Service Bulletin No 7/2022

Date: 8.11.2022
Product: Daqu 3.0
Subject: Daqu showing wrong RPM value.

Figure 1: Position of screws, other three are on the opposite side.

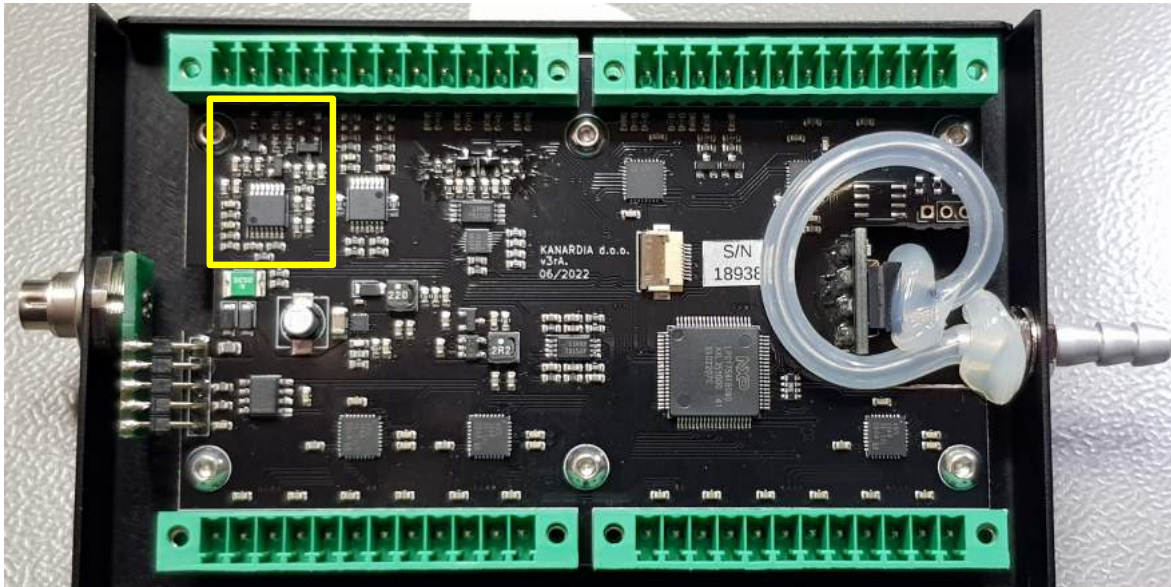
1. Remove 6 screws on the side of a Daqu unit and lift the top housing. See Figure 1.

Figure 2: Yellow square shows location we will be working on.

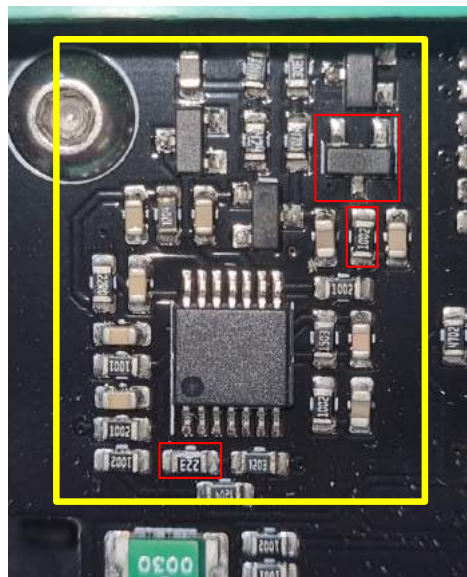
- Working location is shown in Figure 2 (yellow square), components we will be working on are shown in Figure 3 (red squares).

Figure 4: Before and after photo of a diode.

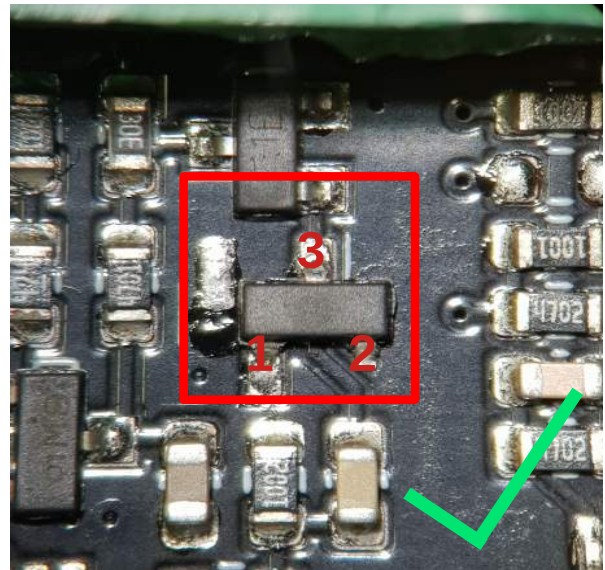
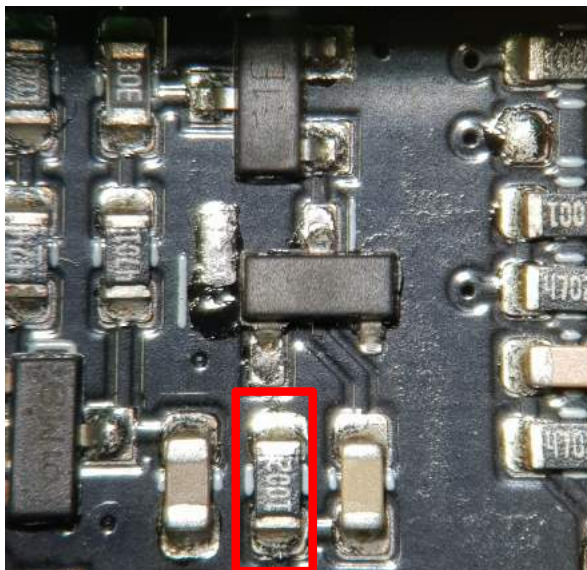
- Rotate diode for 180° as shown in Figure 4. Pin 2 is irrelevant and its not soldered.

(a) Wrong position of the diode.

(b) Diode rotated for 180°.

Figure 5: Before and after photo of removed resistor.

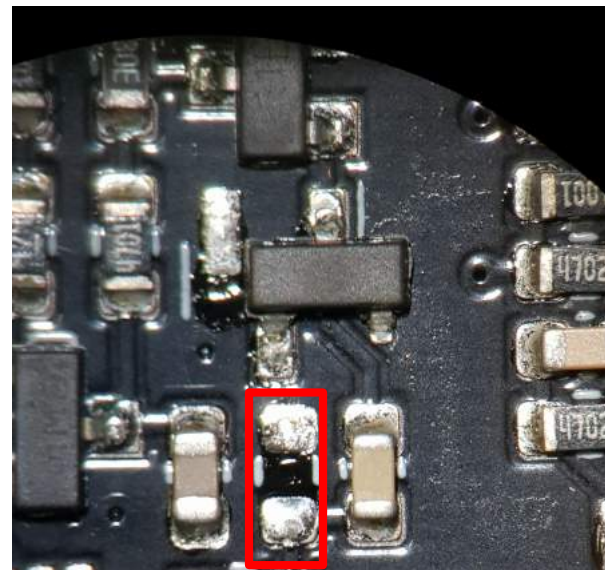
4. Remove the resistor (10k) as shown in Figure 5 and save it for the next step.

(a) Remove resistor in the red square.

(b) Resistor removed.

Figure 6: Before and after photo of a resistors staked and soldered.

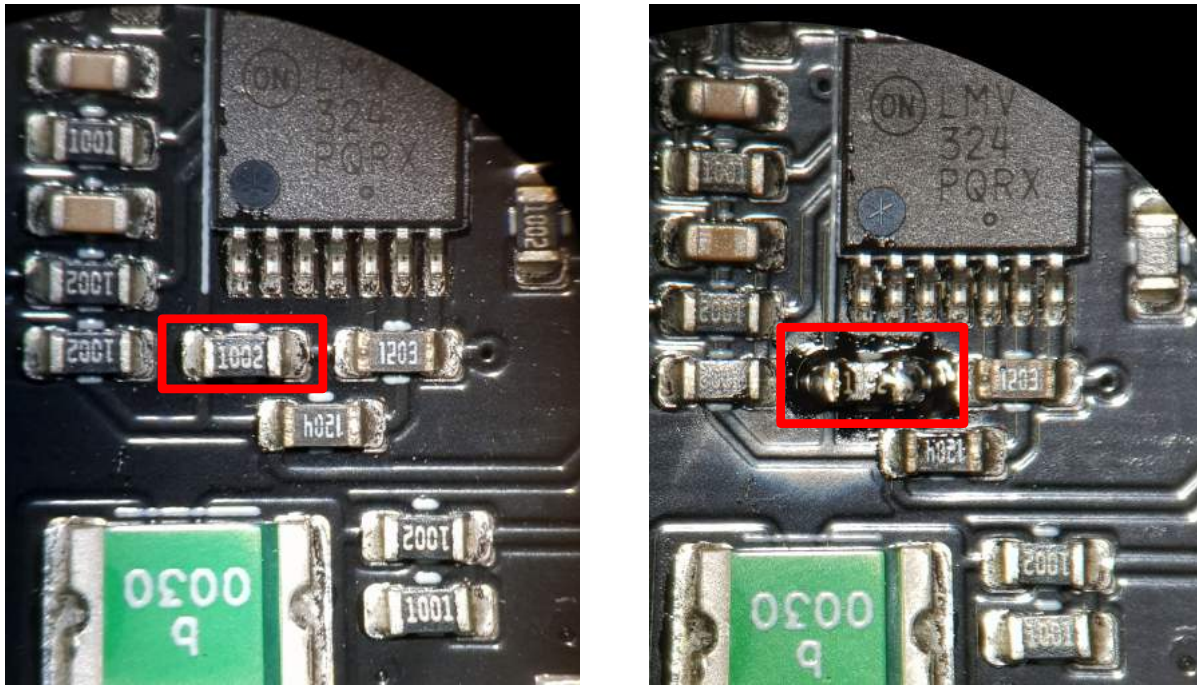
5. Solder/stake the previously removed resistor on top the resistor located in the red square as shown in Figure 5. Side view is shown in Figure 7.

(a) Position where to solder resistor.

(b) Resistor soldered on top.

Figure 8: Connect two pads inside a red square with soldering.

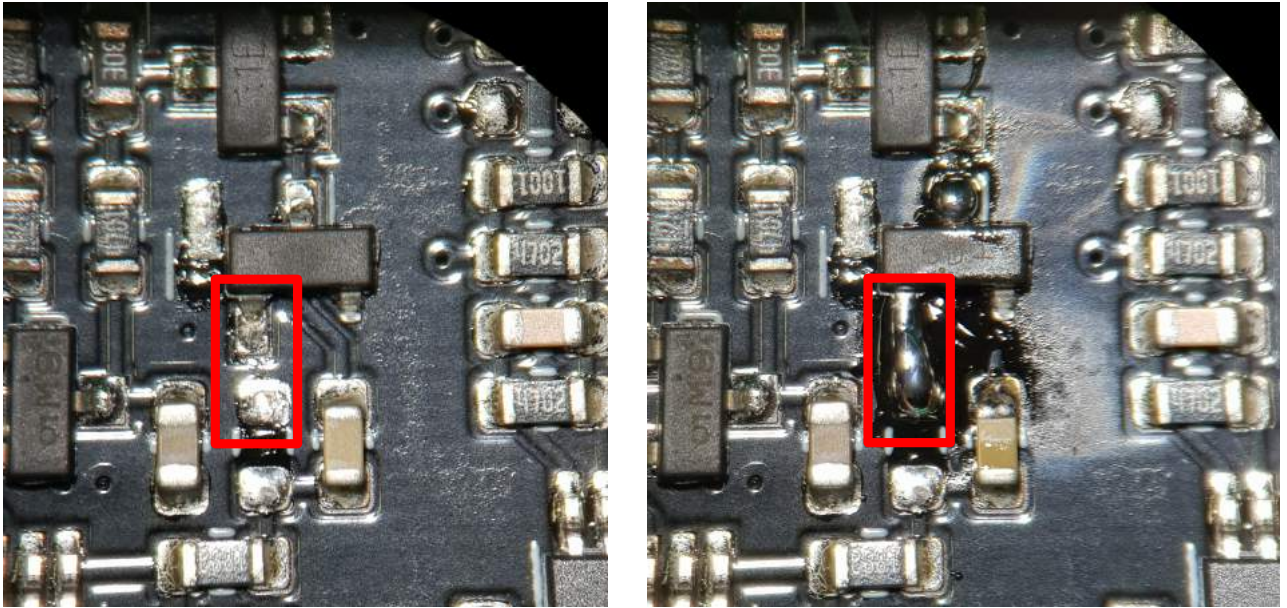
6. Connect and solder two pads as shown in Figure 8.

(a) Pads not connected.

(b) Pads connected.
